Civil & Structural Engineering Review
Report, of

**CBD and South East Light Rail (CSELR)
Project
Environmental Impact Statement (EIS)**

Document No.: 13895 – RBG – ATC - 001

Figure 2.1 - Typical section through Wansey Road Stop (sourced from EIS Figure 10.5).

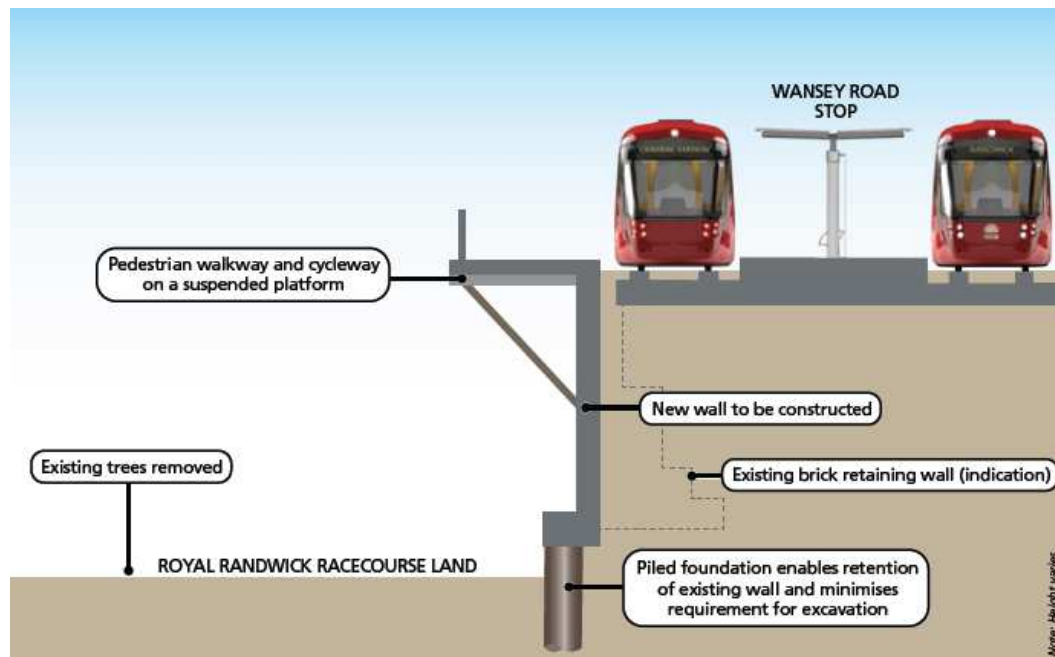
EIS Section 5.6.2 details a suspended shared path over ATC land. The path is suspended off a new concrete retaining wall founded on piles. Wansey Road existing retaining wall to be replaced. Approximately 125m in length up to 4.5m in height. The retaining wall requires land acquisition from ATC.

Construction of the retaining wall will likely impact RRR to enable construction of the piled footing (loss of trees and piling rig access), and maintenance of the suspended path will likely require an easement inside RRR for inspection and maintenance access. The easement must not impact current ATC operations and must cater for the proposed UAP development including basement structure to be constructed without interfering with the High Street and Wansey Road stops.

Treatment of the retaining wall to be confirmed, and considered in relation to the amenity of the future stables development.

A fence providing screening of Royal Randwick Racecourse (RRR) is required from the suspended path to horse training and stabling areas.

RRR vehicle clearances from suspended path to be considered. A vehicle exclusion zone is likely to be required to prevent impacts on the structure. This may impact RRR circulation.

Figure 2.3 – Proposed CSELR trackform type and extents (extract from EIS).

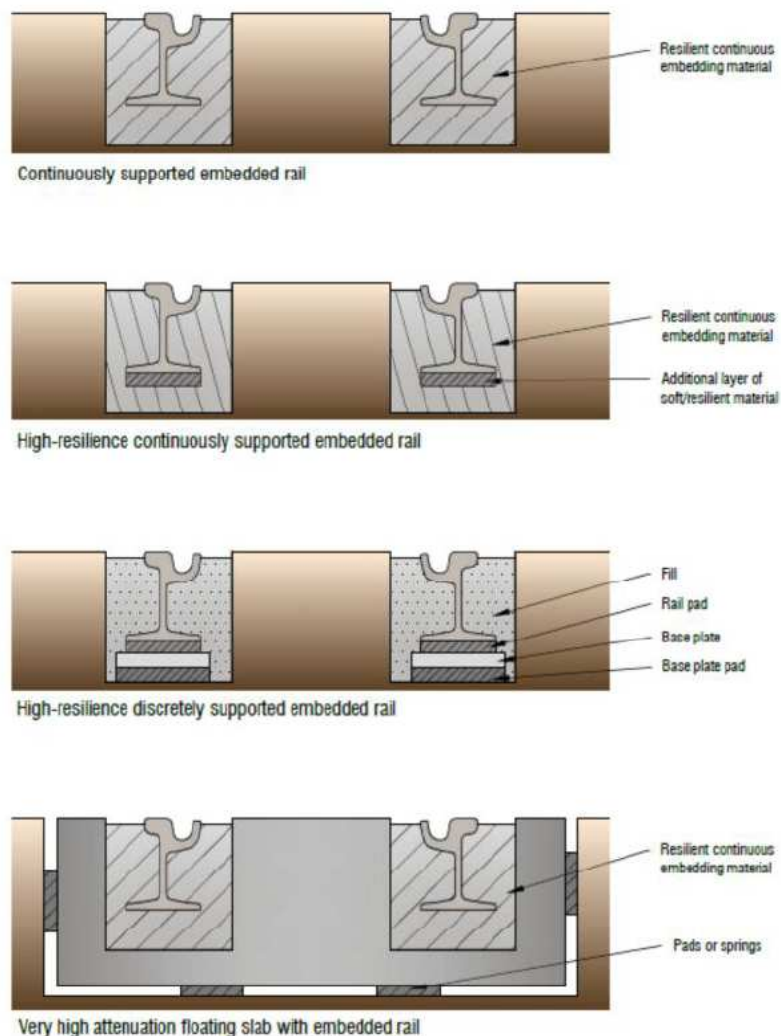
The alignment of the CSELR in the vicinity of the RRR Stop passes very close to the existing ATC Administration Building. The proposed alignment requires demolition of the existing brick wall outside the Alison Road frontage of the building, removal of trees, and impacts on an awning and services.

Other than the impacts noted above, with the alignment passing a few metres from the building, consideration should also be given to

- Vibration impacts on the existing structure and occupants.
- Noise impacts on occupants.
- Pedestrian safety for occupants exiting the building with the rail passing close to the front door.

The use of noise/vibration attenuating trackform should be considered in this area and any areas adjacent to buildings or stables should be utilised to minimise impacts.

EIS Technical Paper 11 – Part A, page 18, notes that noise catchment area NCA05.2 as being a minimum distance of 4m to nearest receptor building façade. Preliminary CSELR alignments would indicate that the CSELR is closer than 4m to the ATC administration building. Technical Paper 11 notes the use of high-resilience trackform to mitigate impacts of ground-borne noise on sensitive receptors. The extracts below from the EIS nominate the proposed trackform options to reduce noise (and potentially vibration) effects on receptors. The Alison Road alignment, including the ATC administration building frontage, is noted as being Standard Trackform. Consideration has been given to the future hotel within the RRR, however consideration should be given to provided noise and vibration attenuating trackform in front of the ATC administration building, and other potentially sensitive receptor areas on the RRR boundary, including existing and future horse stabling.

Figure 2.4 – RRR impacts at Stabling Yard and RRR Stop.

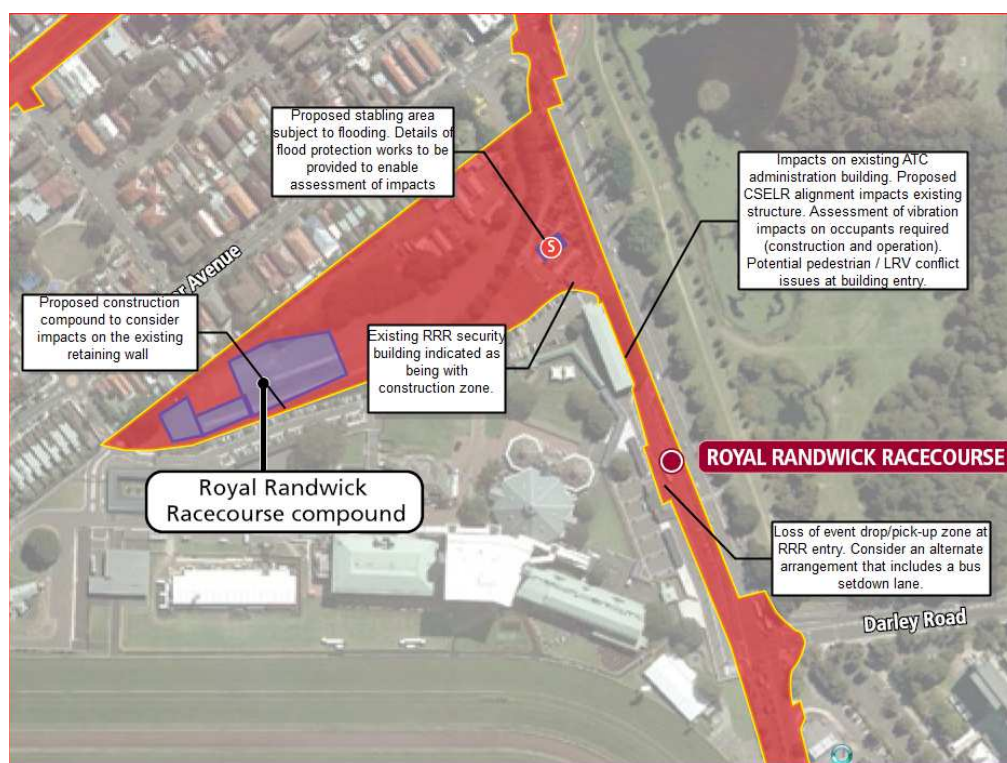
EIS Chapter 19, Climate Change Risk Assessment item 3b notes that climate change causes increased frequency and severity of storm events. The EIS notes that the Randwick Stabling site is inundated in a 1 in 5 year event up to 200mm, and all events beyond this. EIS notes that 15% should be added to rainfall intensities to account for climate change. However, the capacity of the existing network is insufficient to flood protect the system to CSELR criteria. EIS does not propose a solution to this issue. CSELR stabling yard to be located in flood prone land. Construction of the LRB stables in this flood prone land may exacerbate flooding issues elsewhere. CSELR does not propose a solution to flood protecting the stabling yard. There may be an impact on RRR subject to the proposed solution.

EIS notes upgrading the downstream drainage network is noted as potential solution. This may be too large and costly solution for TfNSW. Construction of stabling yards, and filling site for flood protection, in what appears to be flood backwaters, may cause flood impacts elsewhere. EIS notes detention as option. This is likely to be a significant volume (to replace lost flood storage volume) and there may be issues getting a hydraulic solution that does not involve pumping.

Figure 2.5 – Proposed stabling yard facility with RRR.

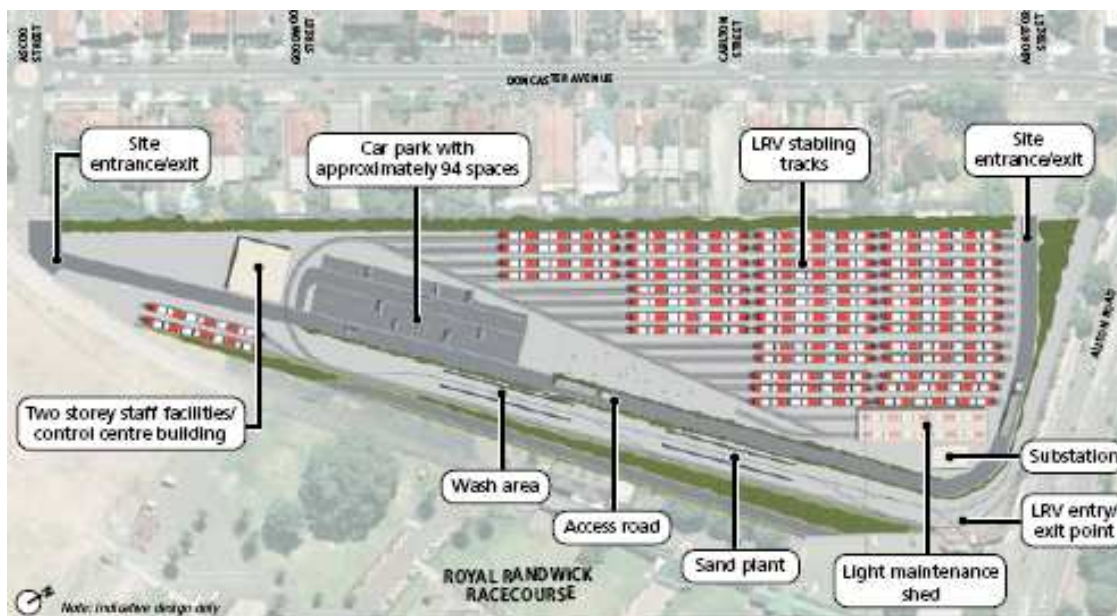
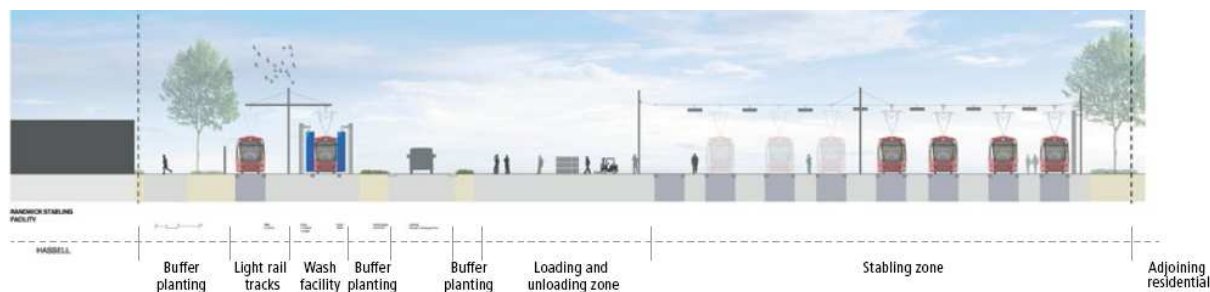
The EIS notes that a 6m noise wall will be constructed between the residential properties and the proposed stabling yard.

EIS focused on impacts to the existing residential properties. Limited discussion or assessment on impacts to the RRR facilities (i.e. administration building, guard hut, event buildings/facilities).

- Consider visual amenity of a 6m noise wall along the boundary.
- Consider light pollution from flood lighting the stabling facility.

EIS notes high groundwater in proposed Royal Randwick stabling site. Proposes measures to protect aquifer from contamination. Mitigation measures not described within the EIS.

Consider impact and possible mitigation measures to protect aquifer against contamination during construction. Noting also that site is subject to flooding.

Figure 2.6 –Proposed UAP future built form within ATC lands (sourced from <http://www.planning.nsw.gov.au>).

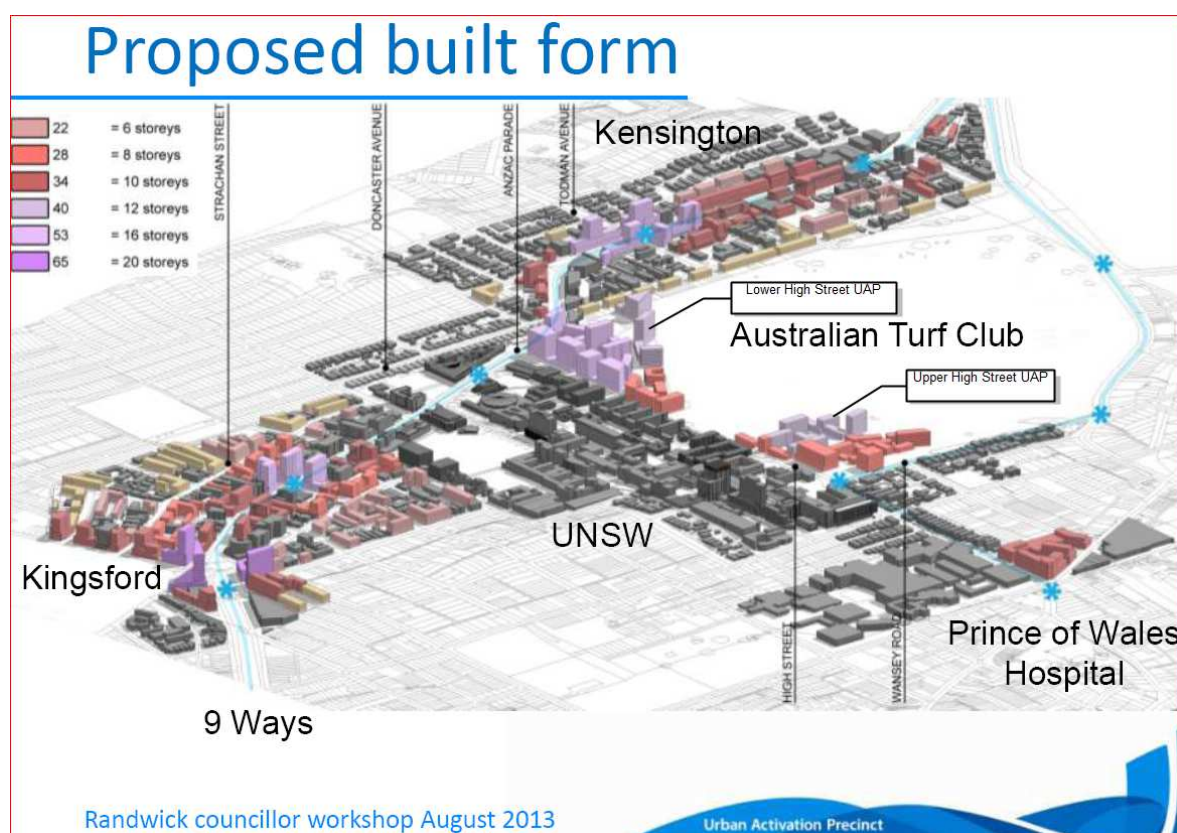
The CSELR proposal may constrain access and servicing to future UAP sites within ATC lands and impact development potential. Current UAP built form densities/heights are indicated in Figure 2.7 below.

- Civil and structural design and construction of the light rail must allow for heavy vehicle crossovers at all existing entrances and exits.
- Civil and structural design and construction of the light rail must allow for heavy vehicle crossovers to approved developments and future urban activation precincts (UAP).
- The engineering of the track and all associated retaining structures must be engineered and co-ordinated with authorities to cater for services penetrations, existing and future provisions.
